Project Advisory Committee (PAC) - Meeting #1 Meeting Summary

On March 20, 2017 the City of Hillsboro Parks & Recreation Project Team met with the Project Advisory Committee (PAC) for the Crescent Park Greenway Trail Plan. The PAC was selected to provide perspective and expertise from a broad range of stakeholders, community advisory boards and professional staff. Members were either appointed by their respective agency or through a formal request at board meetings.

PAC Meeting # 1 Summary

Jackson East Area 3 - Trail Alignments

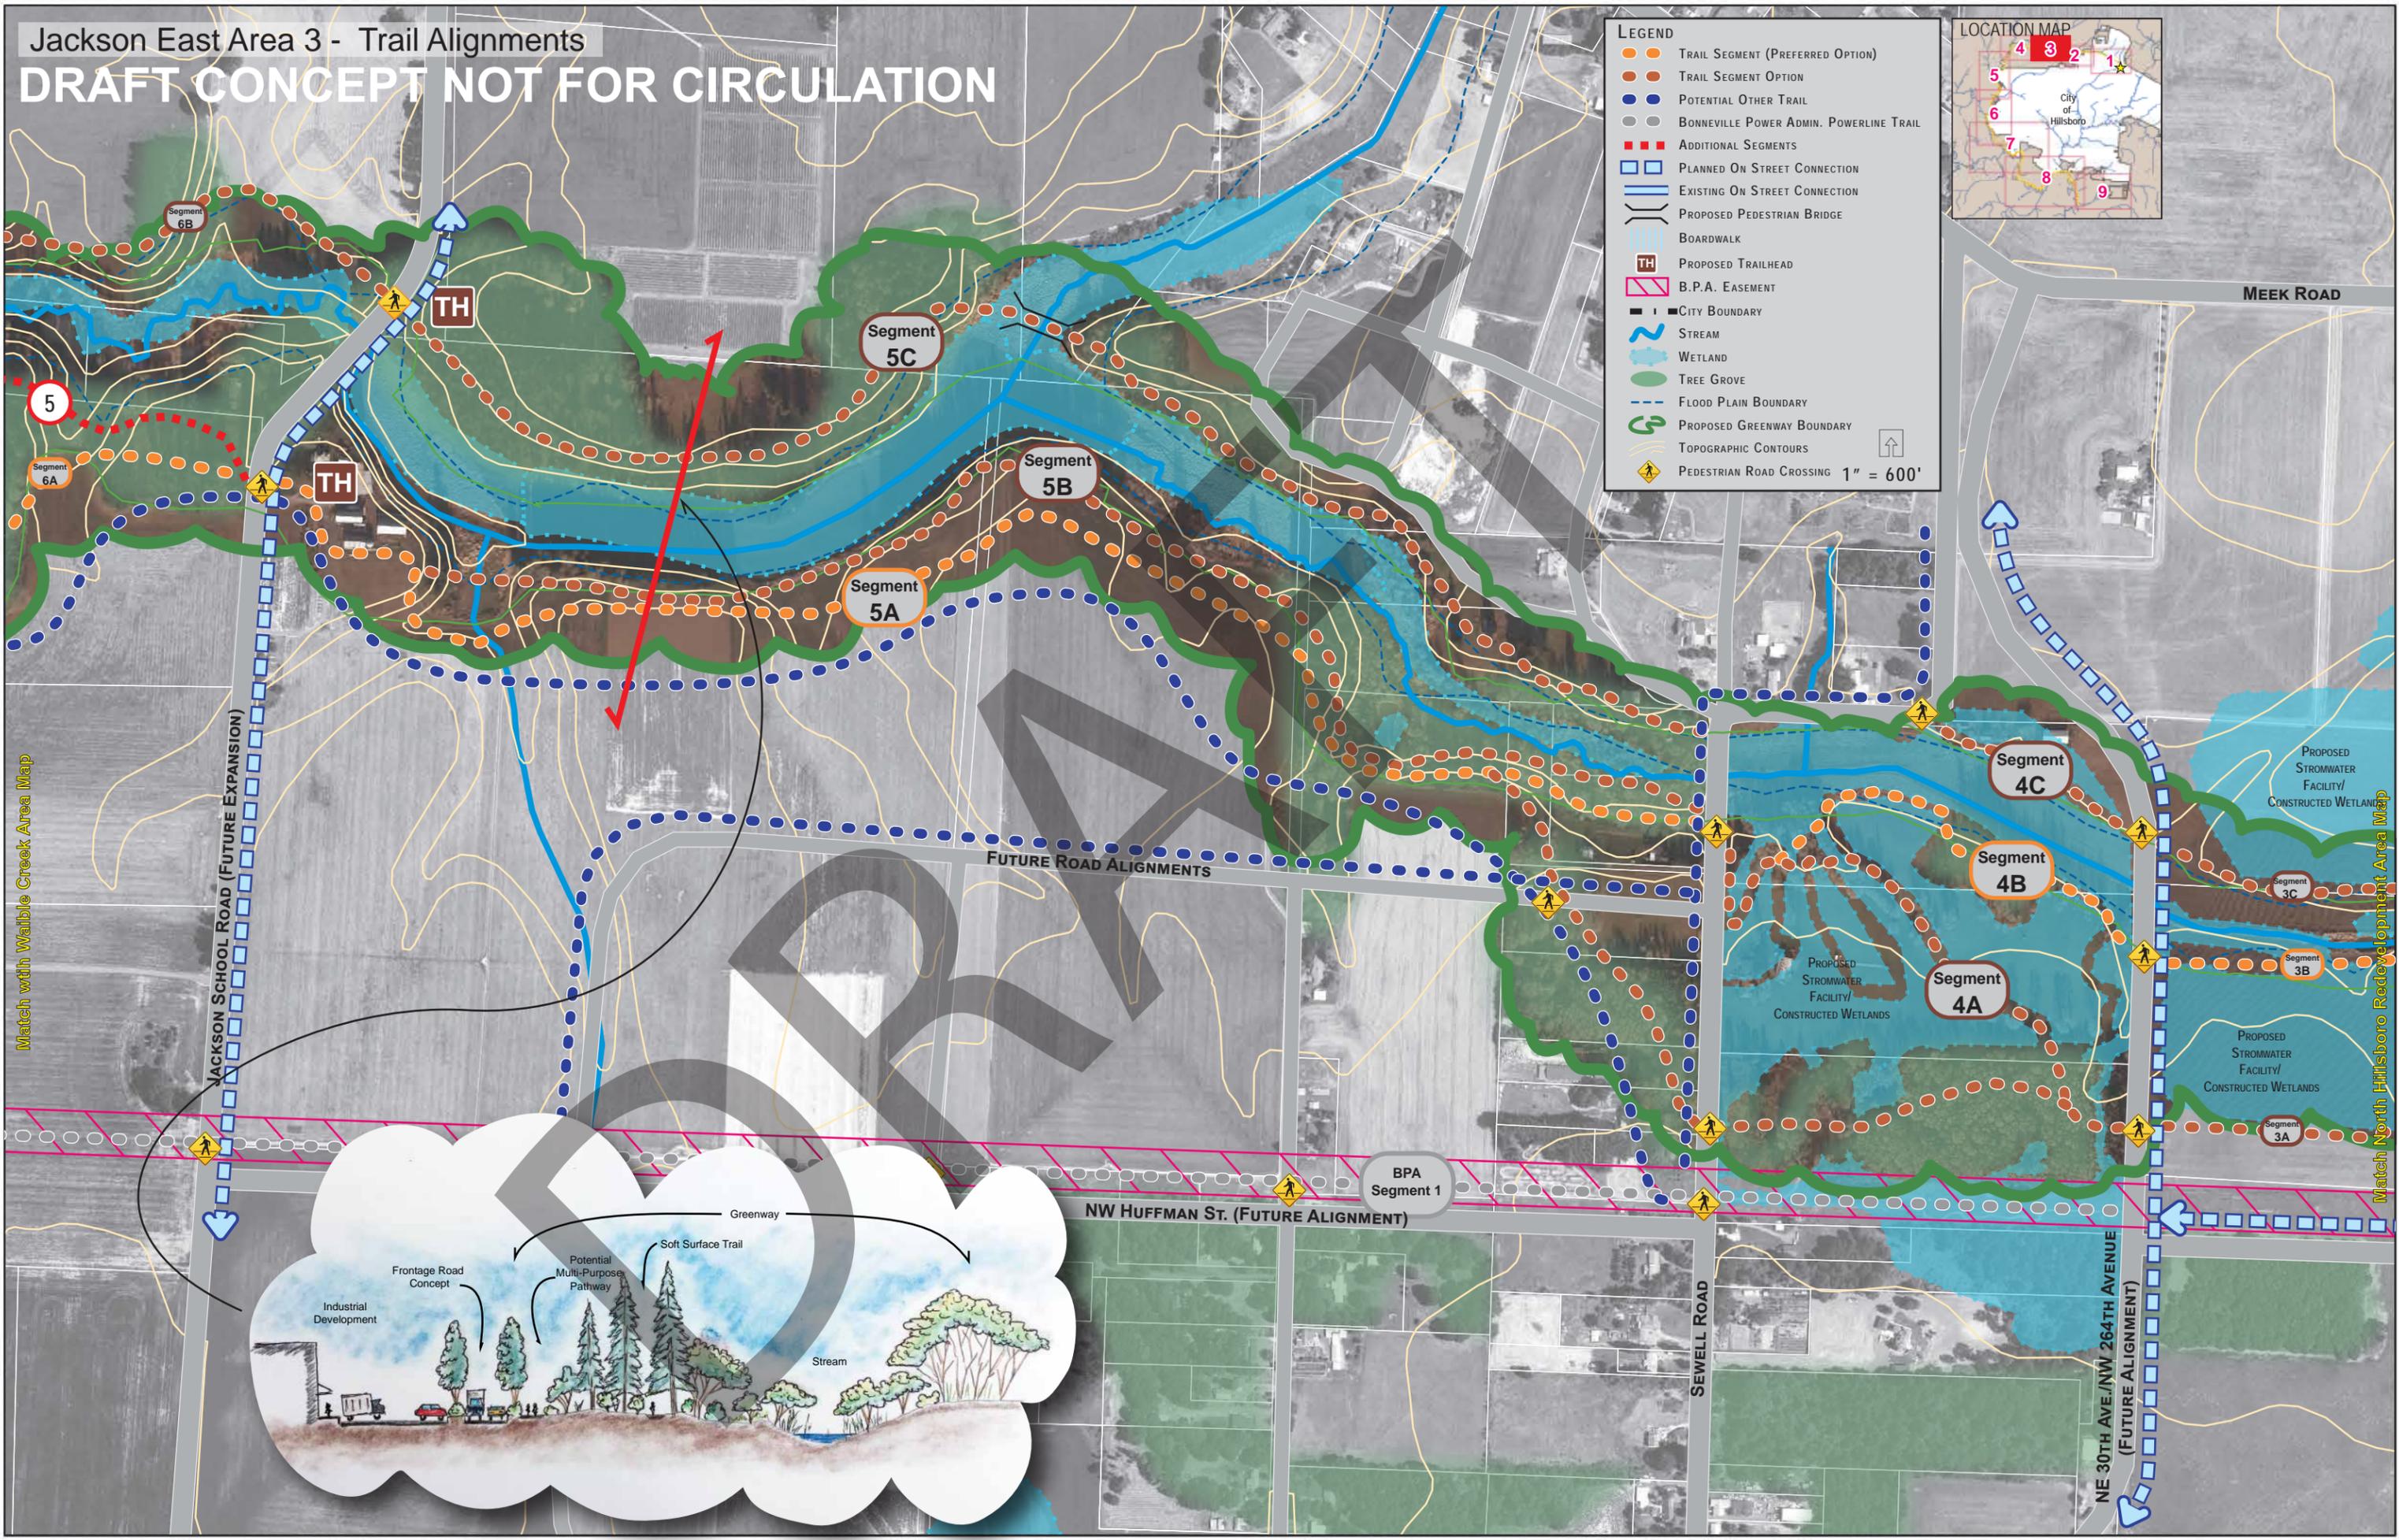
- Work with Transportation to find safer crossings across Jackson School Road and Sewell Road that do not compromise user experience.
- Segment 5C could be a better experience for the user. (Analyze and determine preferred route for this segment).
- Should the CPG keep the re-orientation of industrial building concept in the plan? Work with Dan Rutzick on this and confirm with the group at next PAC.
- Sewell Road alignment may be incorrect. Check with staff for correct alignment and determine trail component.
- Add Runway Protection Zone to maps.
- Connect Huffman Road from NE 30th to Sewell Road.

Waible Creek Area 4 - Trail Alignments

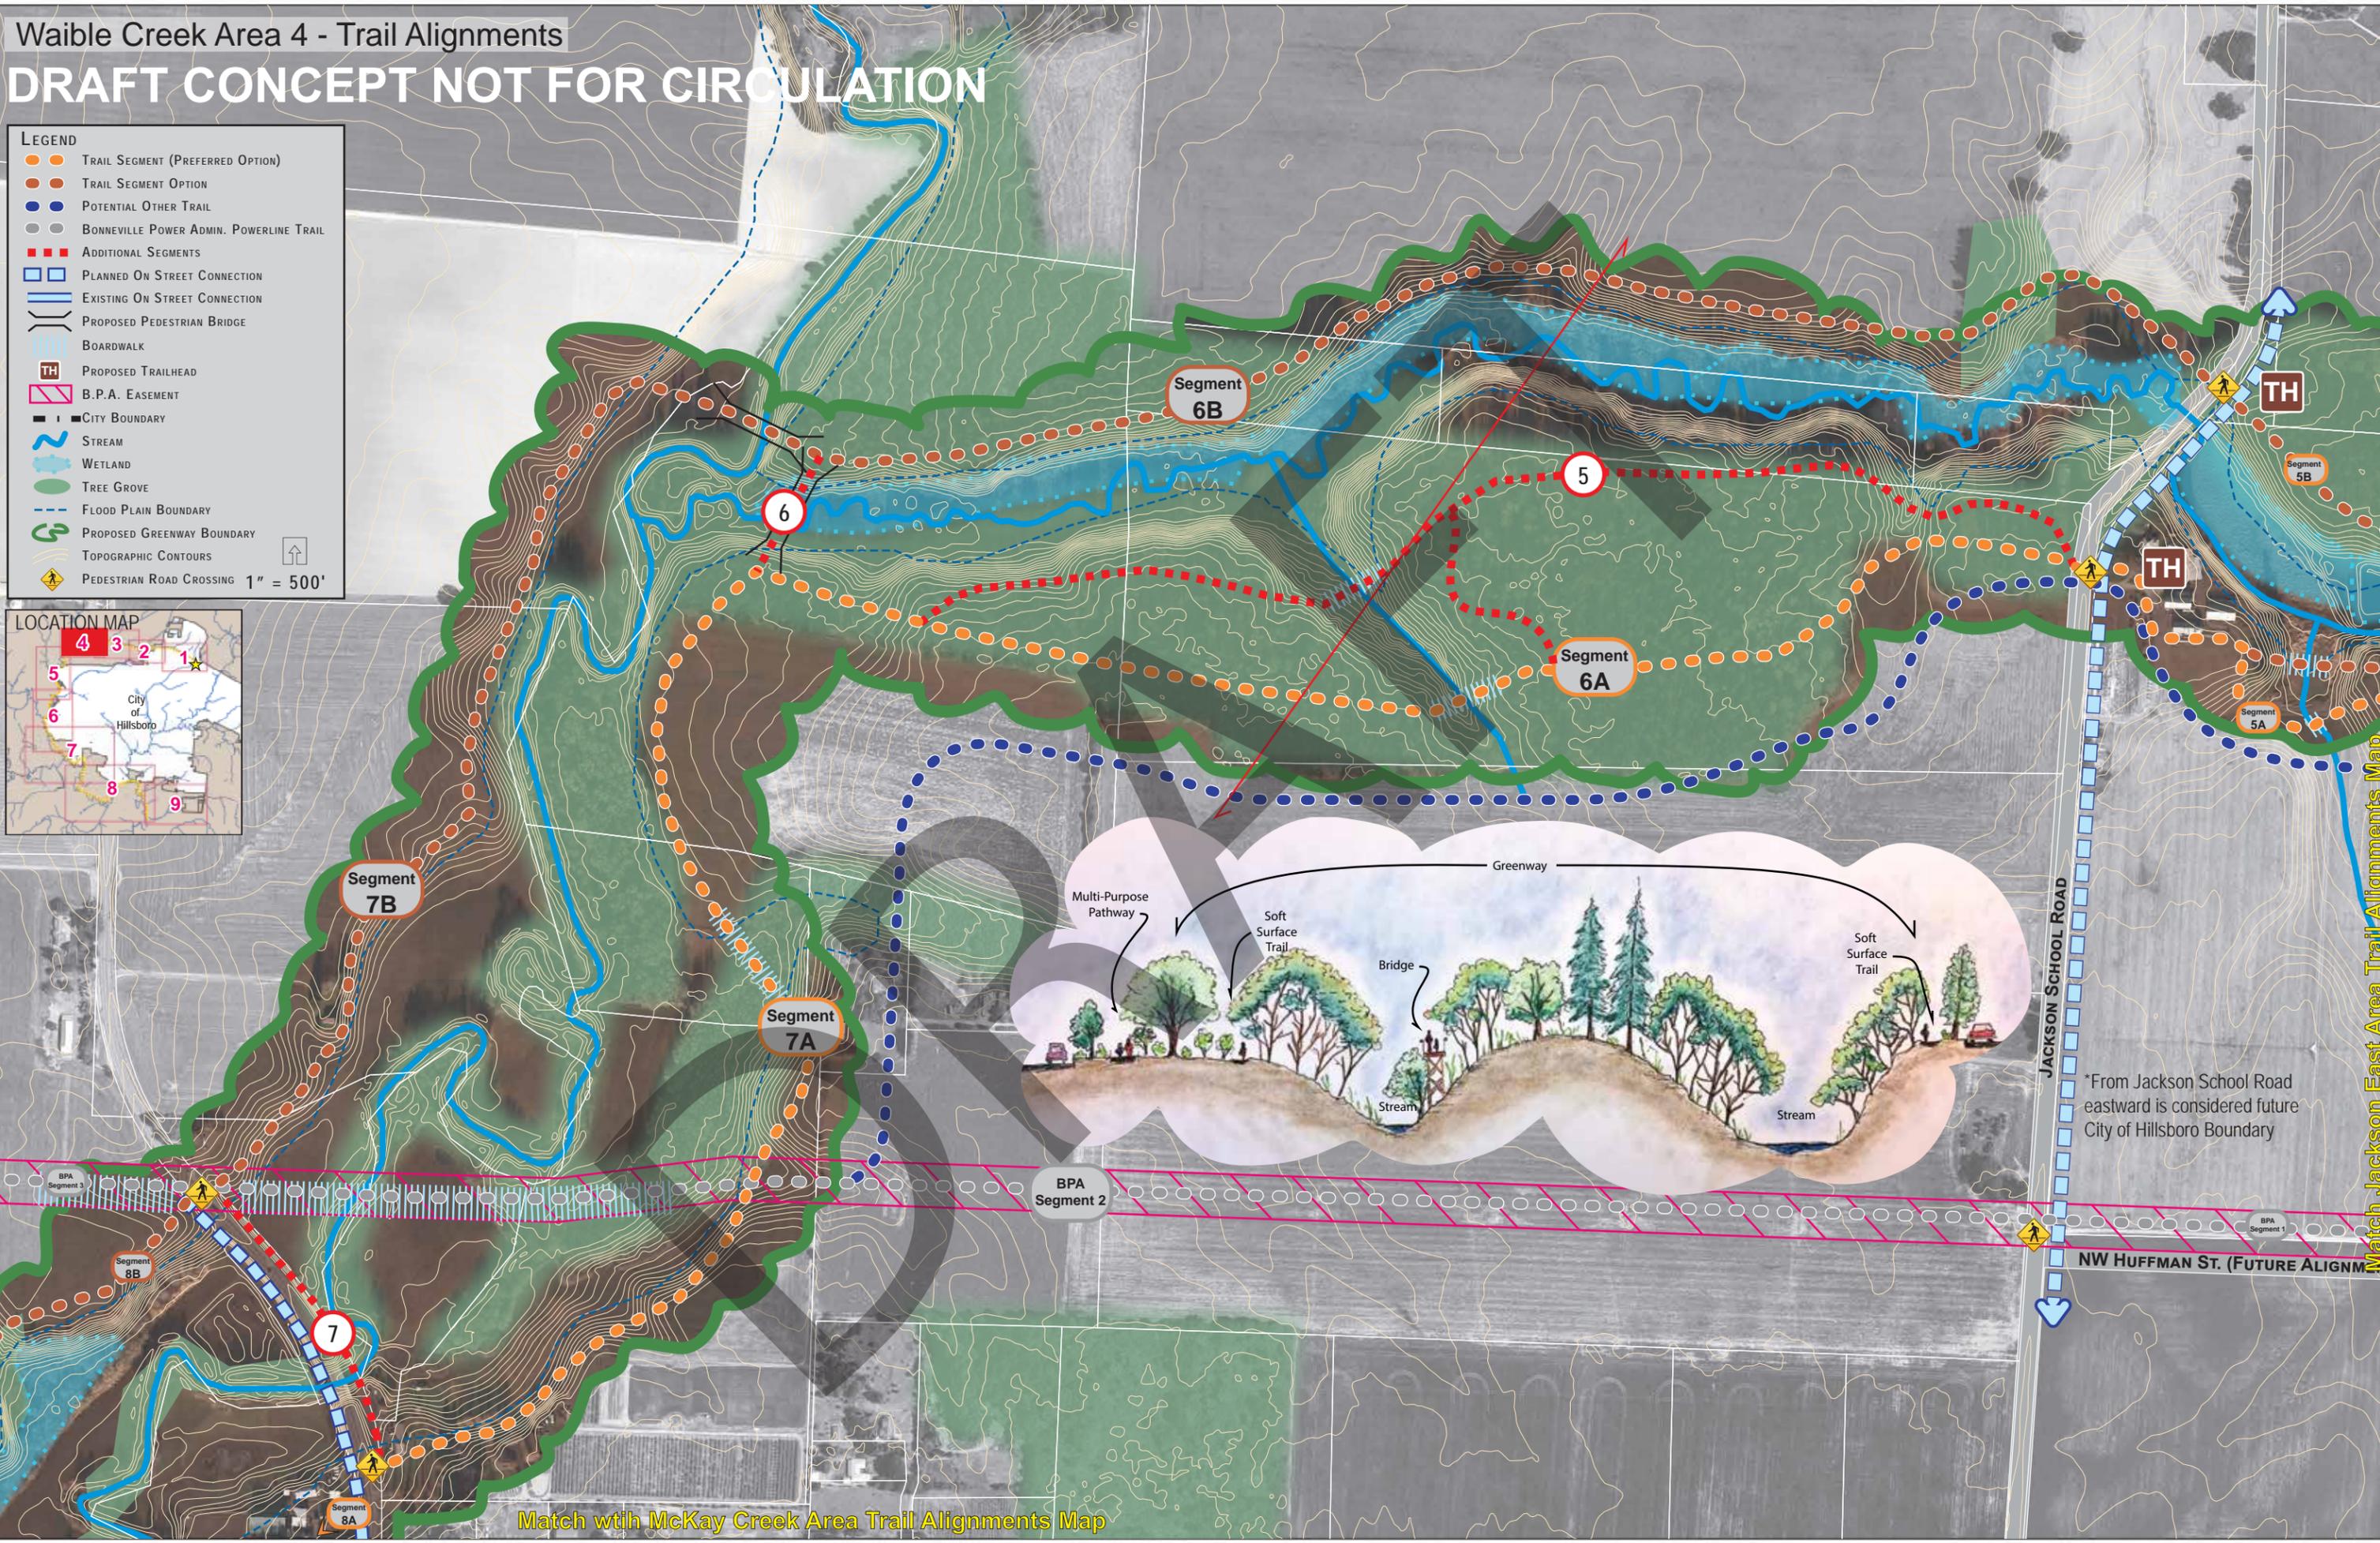
- This section may need to be adjusted to accommodate emergency vehicles as well as larger maintenance vehicles due to distance.
- Large tree grove on south side that is not in the 100yr flood plain is a resource and natural area that is valuable to the community. Try to integrate into the greenway and protect.
- Understand and find a way to balance future development with protection of resource areas and trail experience. Consider future development and implications (work with Dan Rutzick).
- Add North Plains regional trail alignment to the map.
